Addendum #2

RFP # 7449753

TITLE: Field Lighting System Replacement Project @ McCoy Stadium.

ADDENDUM NUMBER TWO

SKETCH
OA-02
25 MAY 2012

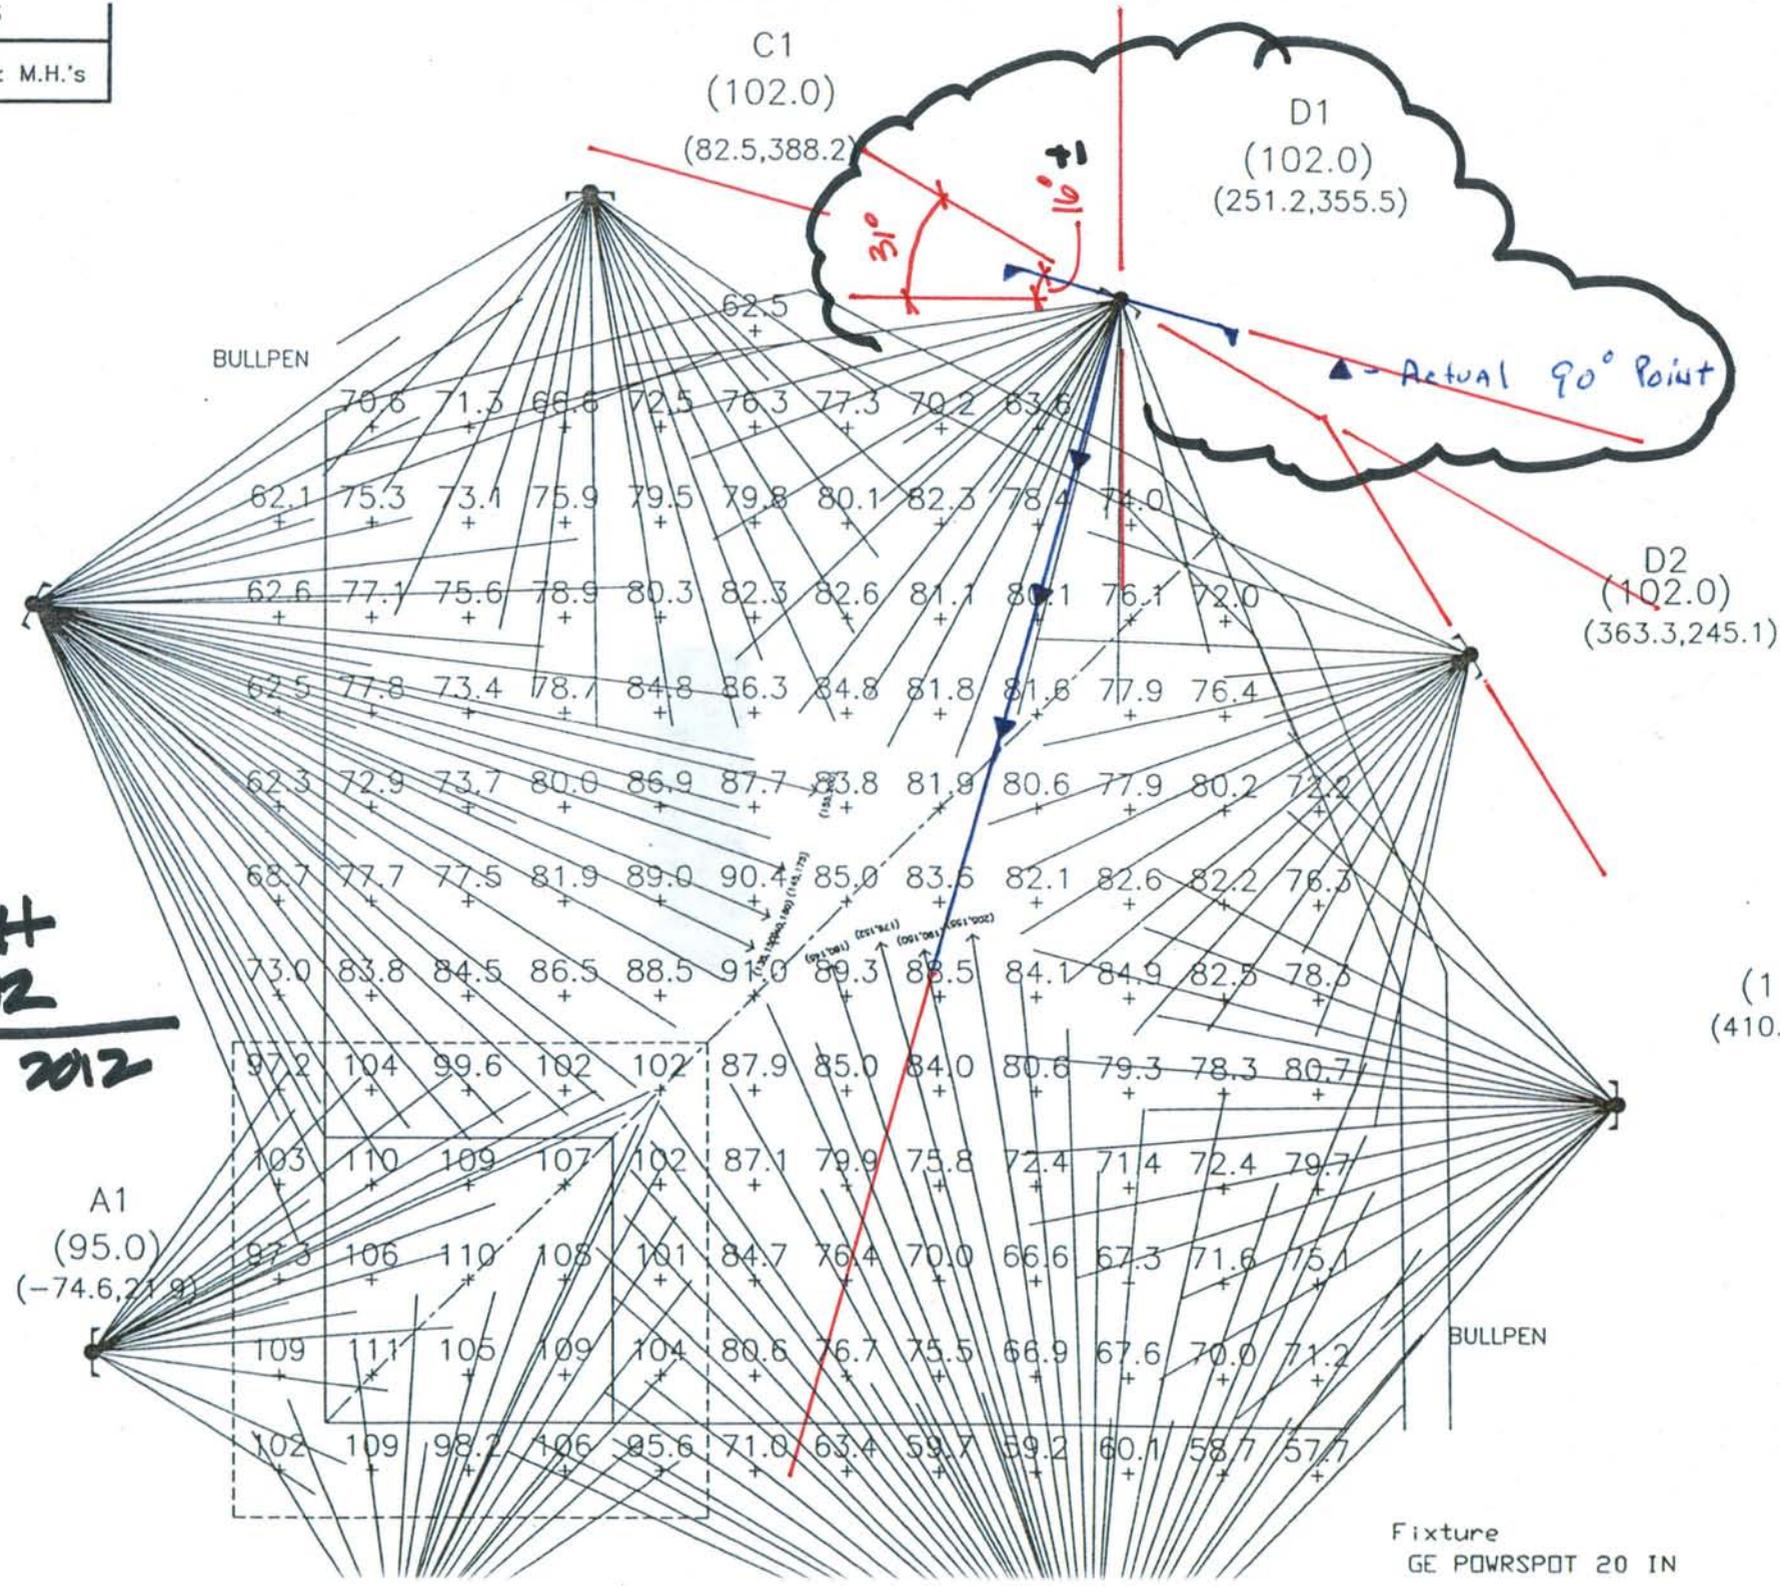
Two supplementary sketches have been provided to indicate that the rotation of the cross arms for pole D1 are not in a standard orientation to the field of play. OA Sketch -01 and 02 are provided which indicate the anchor bolts for the original pole orientation, planned to allow the cross arms to be 31 degrees off parallel (clockwise rotation) with the 1st base line, were incorrectly placed. This resulted in the orientation of the fixture cross arms being approximately 16 degrees off parallel with the 1st base line. The Contractor shall take this existing condition into account when designing the lighting system.
